September 25, 2023

RE: Review of File #Z22-423PSP (Crestview Estates Preliminary Short Plat)

This letter is to inform you that the application materials for the above mentioned Preliminary Short Plat were found to be technically incomplete on September 22, 2023, based on a review required under Spokane Municipal Code (SMC) 17G.060.090, Determination of a Complete Application. The following comments were received from various departments and agencies. Please see corrections requested from engineering specifically.

REGARDING: Storm Drainage Report

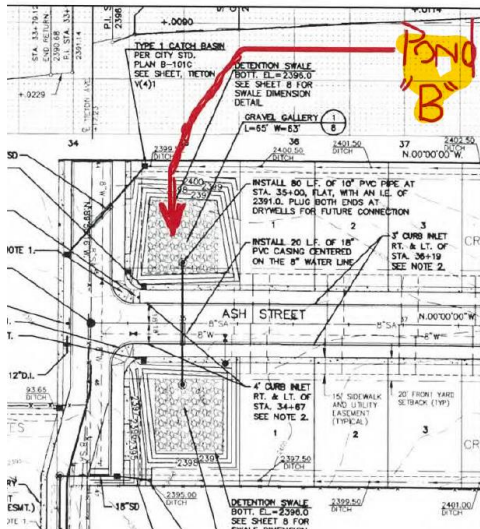
- a. Please stamp the report and remove the preliminary stamp.
- b. Correct the spelling of storm on the first page.
